## TRANSPORT NOTE

**Project Title:** Northwood & Pinner Cottage Hospital, Pinner Road, HA6 1DE

**Report Reference:** JNY10245-07

**Date:** 12 October 2023

## **Appendix A – Comparison Drawing Between Planning Approved Scheme and Proposed Section 73 Changes**

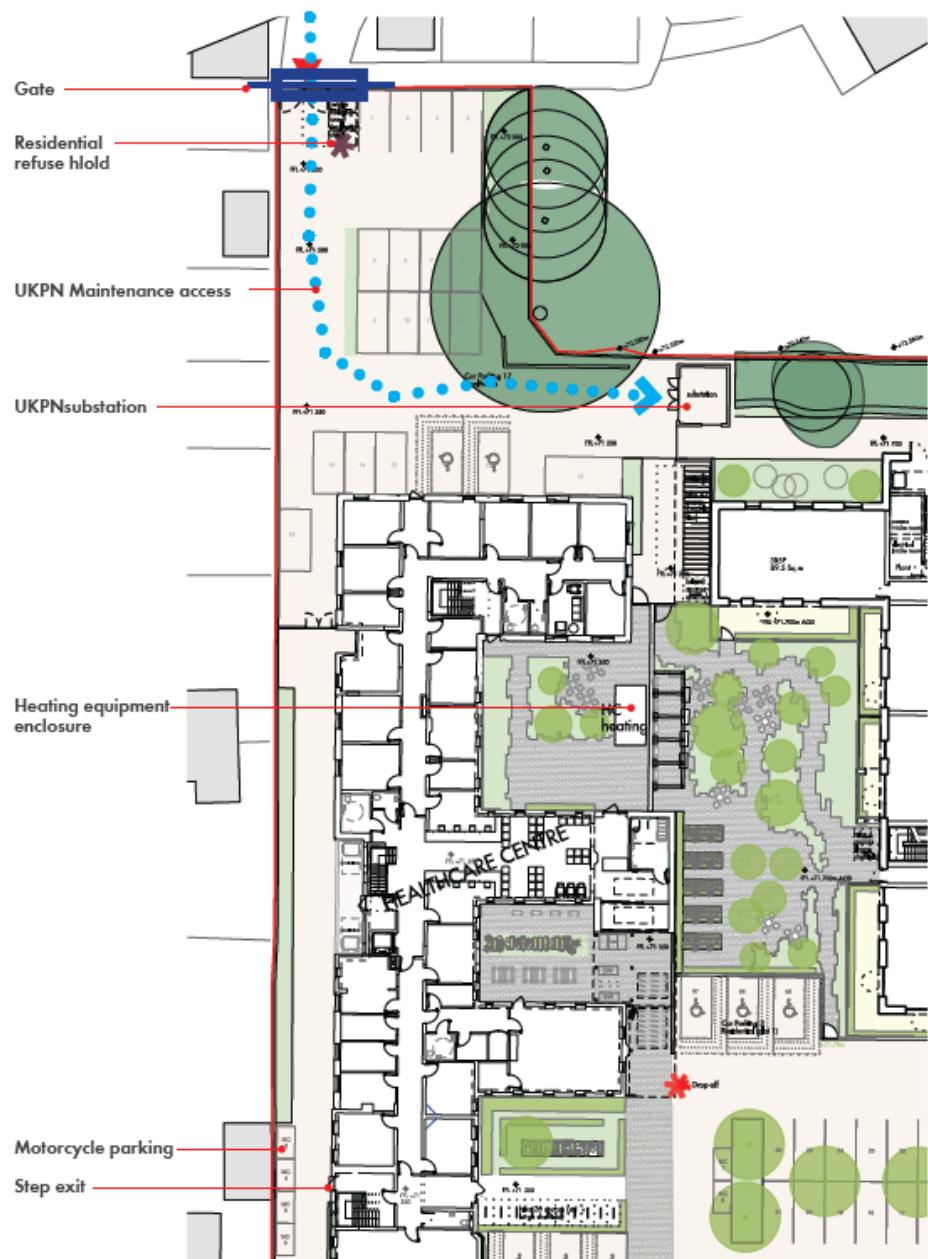
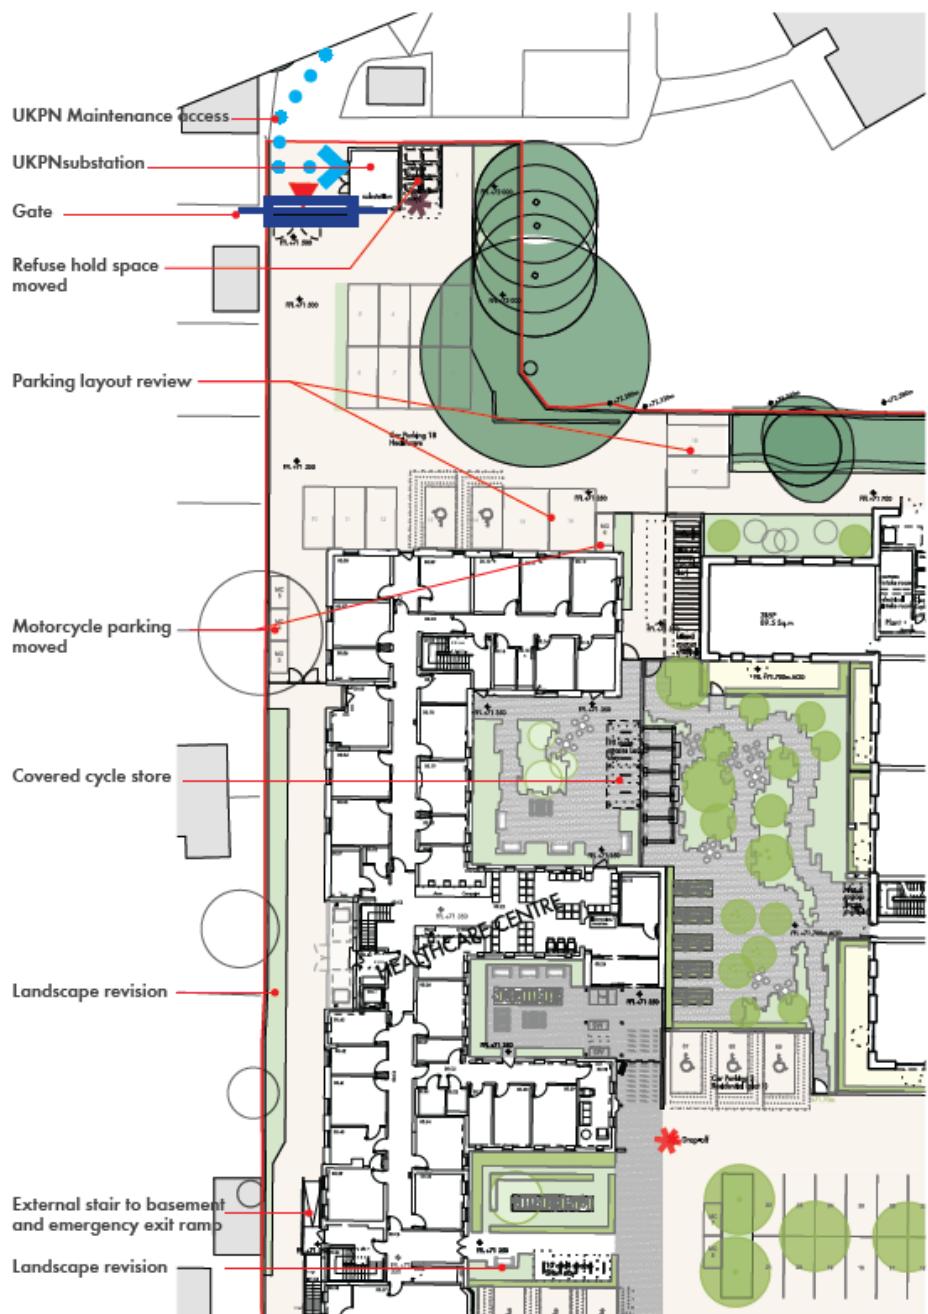
- UKPN Sub-Station
  - Access Gate (Juniper Court/Neal Close Access)
  - Refuse Holding Area
  - Motorcycle Parking
  - Cycle Parking
- 1.6 **Appendix 1** provides a comparison drawing between the Consented scheme and the proposed Section 73 with annotations highlighting the changes.

1.7 Early discussions with LBH Design-Out Crime Officer and initial consultation with UKPN has highlighted a conflict of requirements on the type of security locks, operation and management of the vehicle gate to the north car park (staff car park) that in the consented scheme provides access to staff as well as maintenance access to the substation. UKPN require the sub-station is accessible at all times and is not contained behind a security gate access. Therefore, the only satisfactory solution to this is to reposition the substation so that maintenance access is directly from without the need for access to be through a security gate. Therefore, the security gate has been moved and the UKPN sub-station relocated to accent the vehicle access. The relocation of the security gate does not impact of hinder cars or the refuse vehicle on collection days.

1.8 The refuse holding area has been relocated 2-3 metres from the planning approved location. The relocation was necessary to allow for the relocation of the UKPN Sub Station closer to the staff car parking access. The relocation of the refuse holding area will not impact the waste operative's ability to safely manoeuvre the waste bins from the refuse holding area to the rear of the refuse vehicle on waste collection day. The drag distance between the holding area and the rear of the refuse vehicle are still with 10 metres.

1.11 Following the requirement to relocate the UKPN sub-station to be near to the site access this has subsequently had a knock-on impact to the security gate location, refuse holding area and car parking layout.

1.12 RPS and the design team has reviewed the above requirements and sought to reconfigure the car park layout as efficiently as possible in order to re-provide the planning approved 19 car parking spaces. Unfortunately given the above new constraints only 18 car parking spaces can be provided with the space available. The 18 car parking spaces still provides two blue badge parking bays and has been configured based on vehicle tracking.

1.15 Four motorcycle parking spaces were approved for the health centre use. These four spaces were located to the side of the health centre and were designated for staff only. These spaces have now been relocated so that they are adjacent the main car parking area to the rear of the site. All motorcycles would access via the Juniper Court/Neal Close access.

1.17 The cycle store has now been split in two following feedback from the Access consultant who recommended some cycle parking to be located more centrally within a central enclosed and secure courtyard. Therefore, ten long stay cycle parking spaces have been relocated from the drop off zone to a central courtyard area. The central courtyard will provide covered and secure cycle parking for staff. The overall 20 cycle parking spaces matches the same number as that approved as part of the consented scheme. The minimum required number of cycle parking spaces, based on the cycle parking standards, is 11 spaces therefore the updated scheme is still providing nine spaces over and above the minimum number required.

Title Refuse Vehicle Swept Path  
Analysis

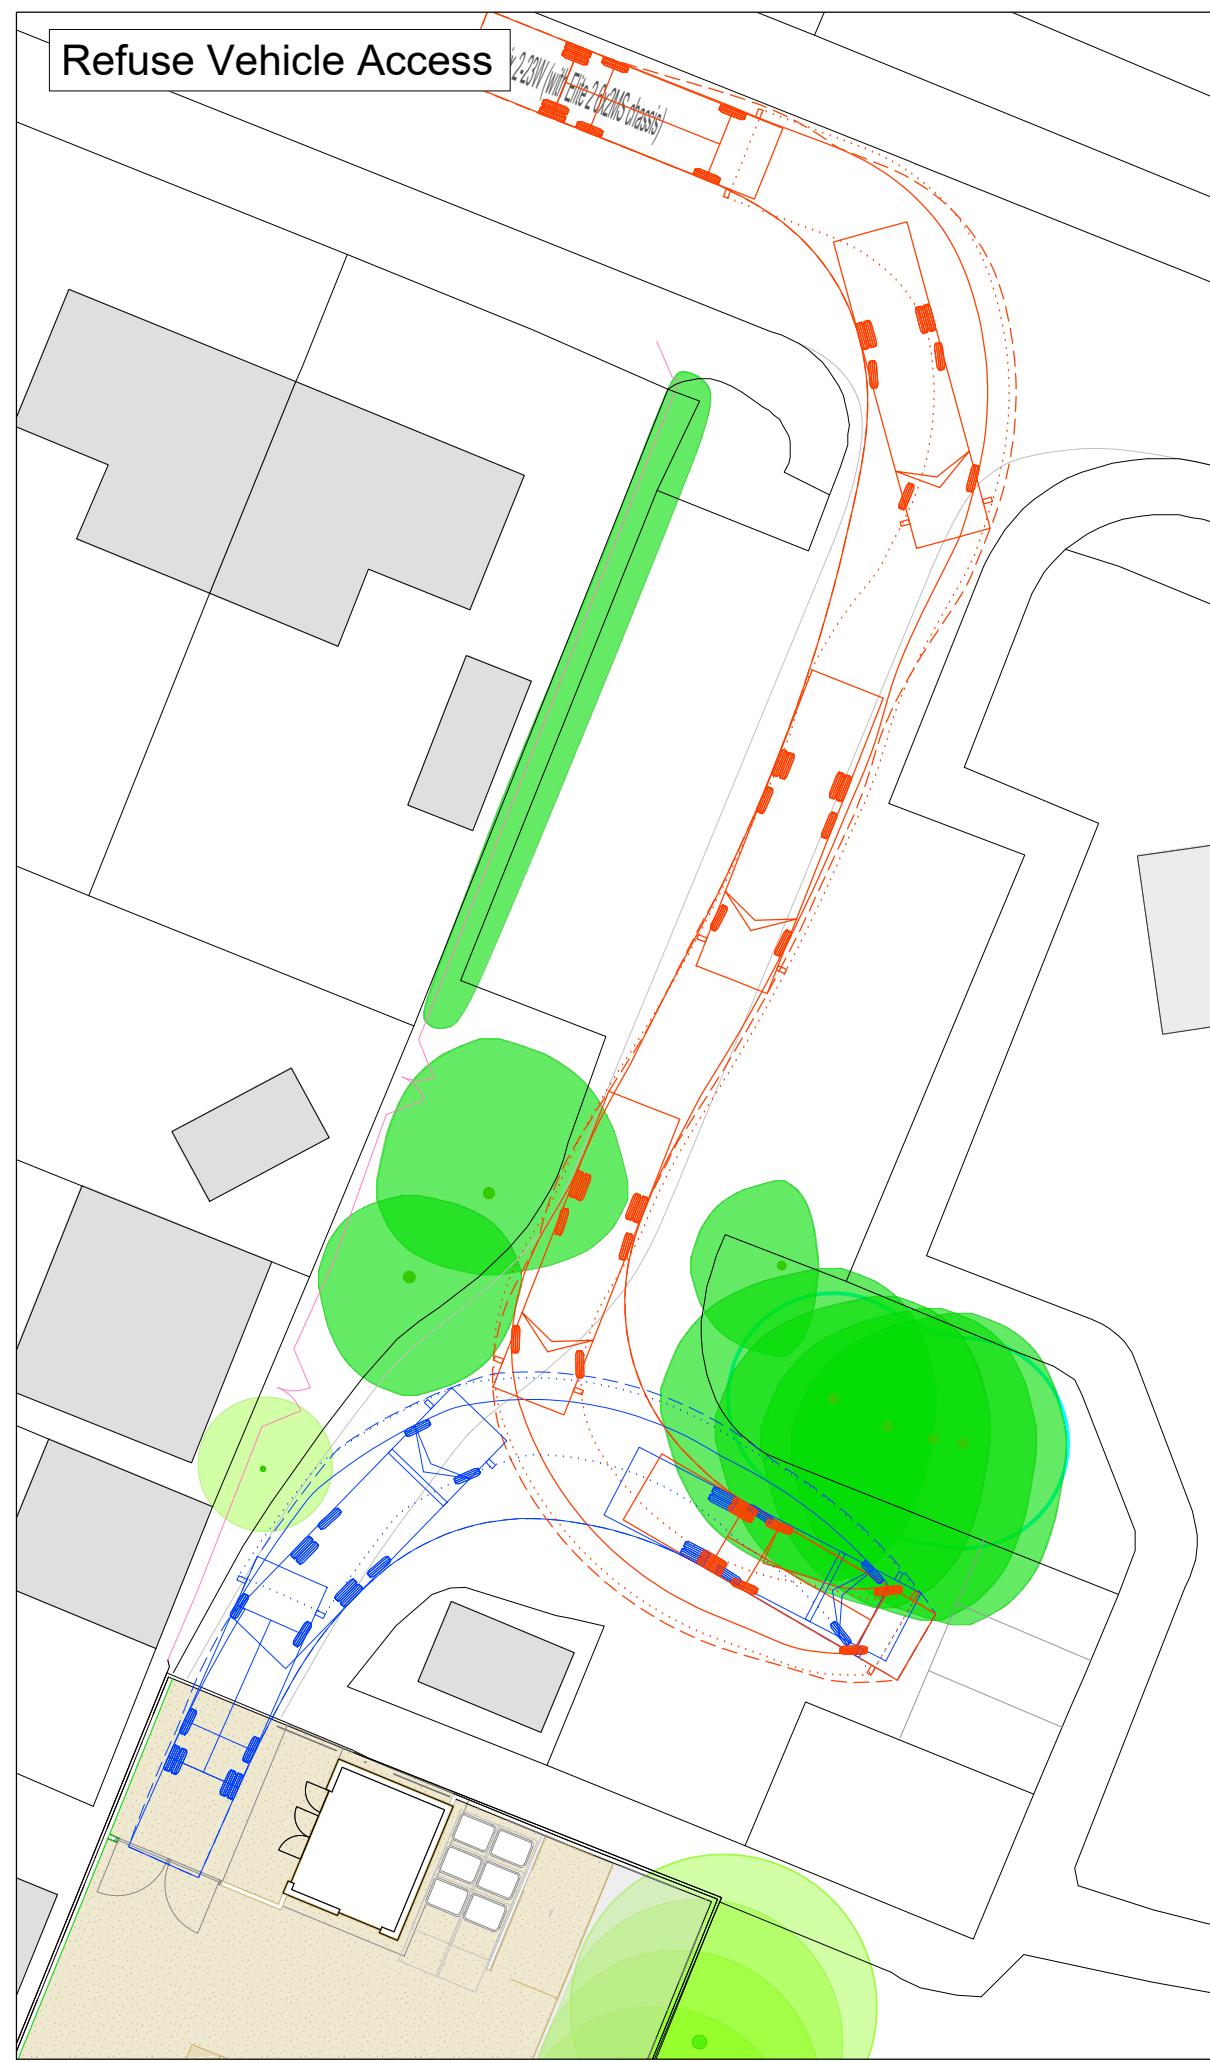
1.9 The vehicle tracking for a refuse vehicle is shown at **Appendix 2**.
